PLAN COMMISSION STAFF REPORT

Agenda Item: PC 24-012

Application Type: Development Plan

Property Address: 9900 Columbia Avenue

Sheet Name
SITE LIGHTING SITE PLAN
 Sheet Number
ES101
 © 2024 Ridgeland Associates, Inc.

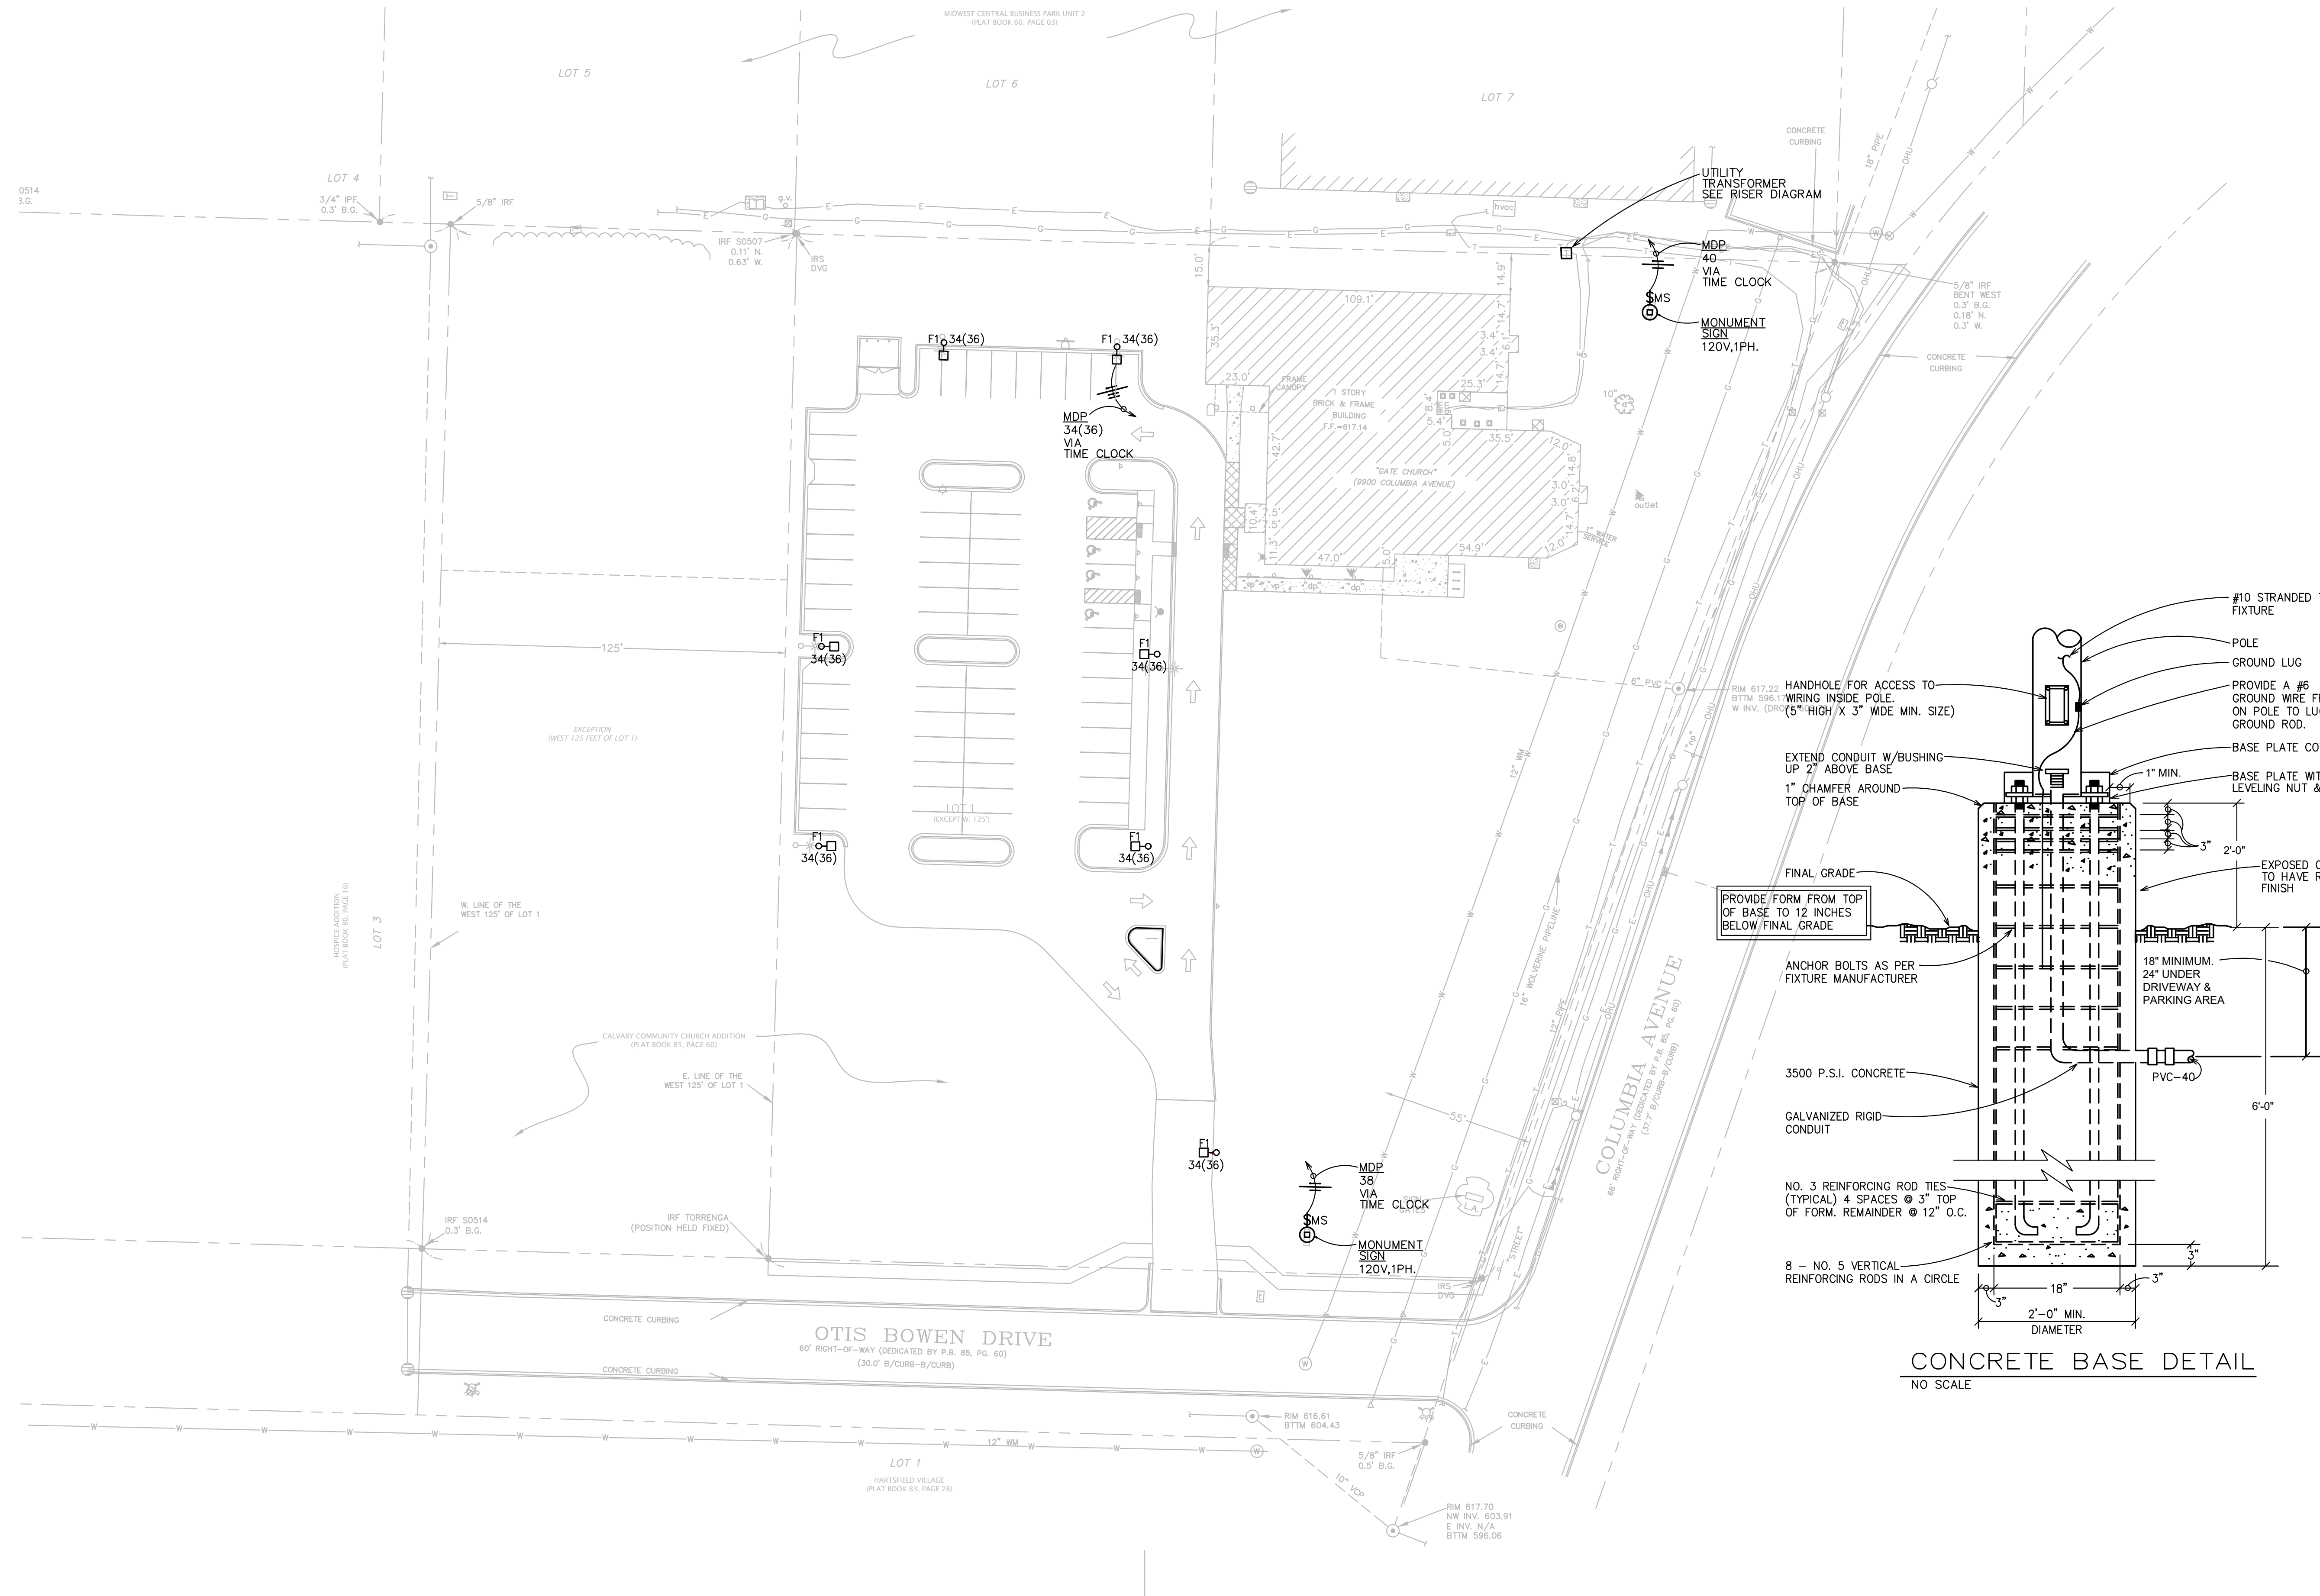
In review of the Development Plan Application and supporting documents staff is requesting additional information regarding the lighting plan to include pole detail and head type. As well as proposed sign package. The applicant has submitted additional information regarding site lighting plan and monument signage.

Motion to APPROVE PC 24-012 Development Plan for 9900 Columbia Avenue with the condition that all lighting specs and signage comply with the character based zoning code, including all discussion and findings.

3 MONUMENT SIGN 2 1/2" = 1'-0"

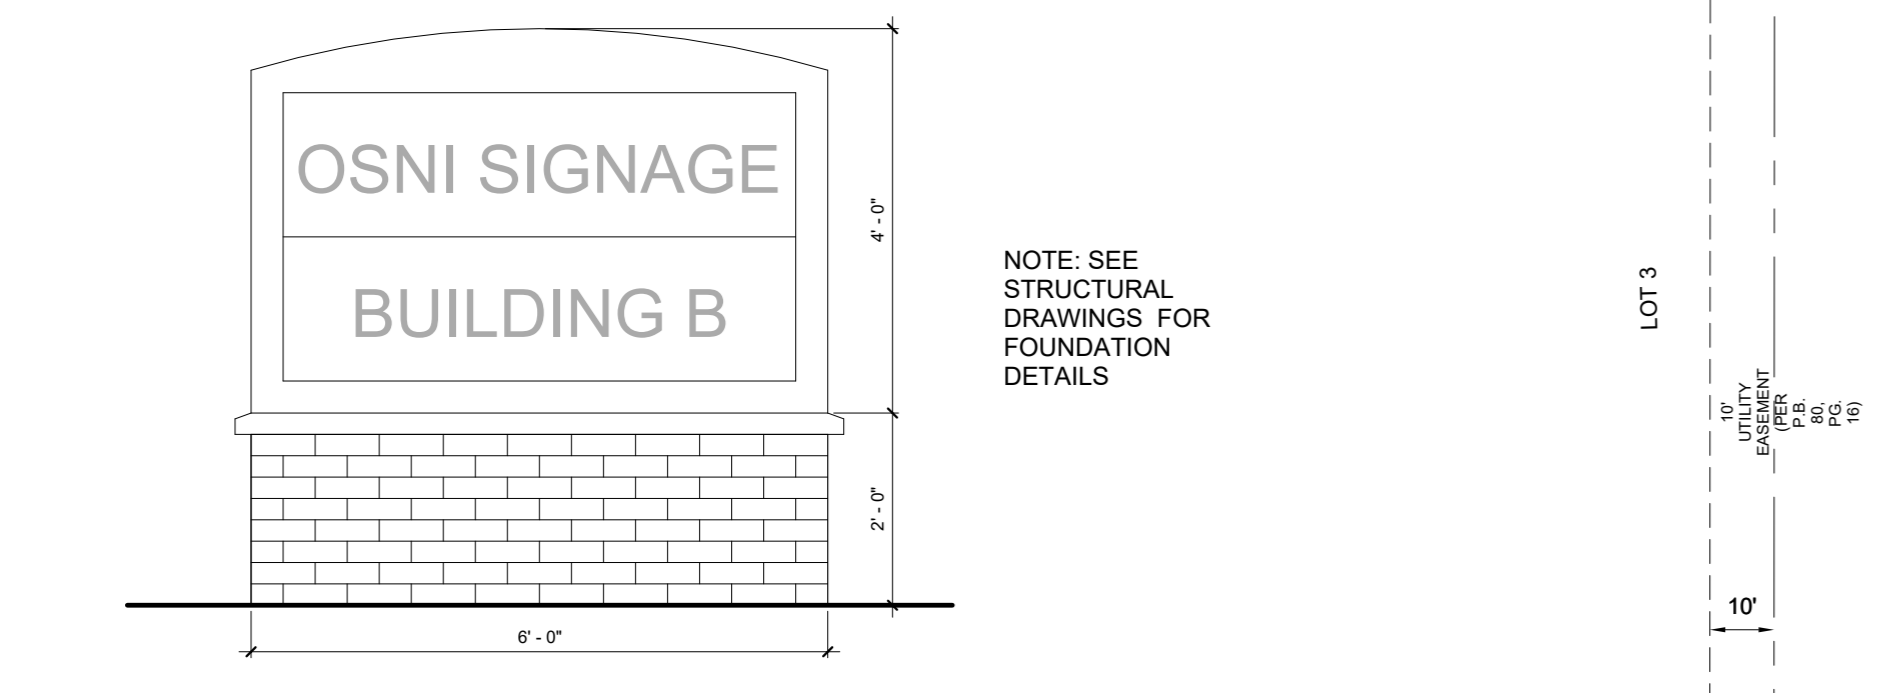
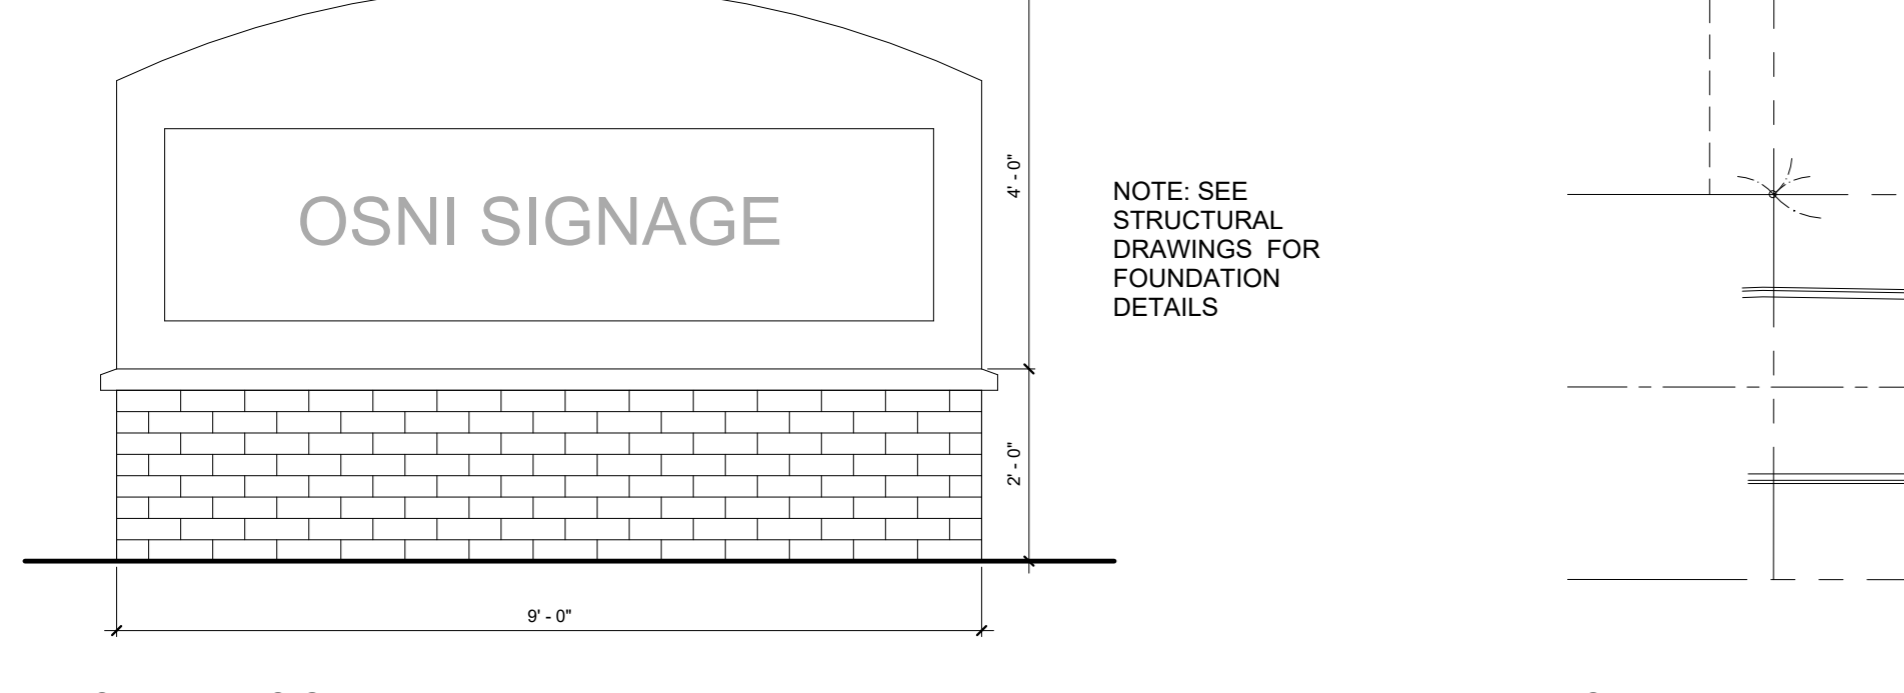
Staff is unclear if the monument sign plan is current because the plans identify an expanded parking lot and future phase 2 of a building. The applicant should provide clarification on the monument plan submitted, one or two monument signs. The monument sign specs submitted appear to meet the zoning standards of 6' H max and 18 SF sign area. Sign material has not been identified and may require a Developmental Standards Variance upon review of a submitted sign permit application.
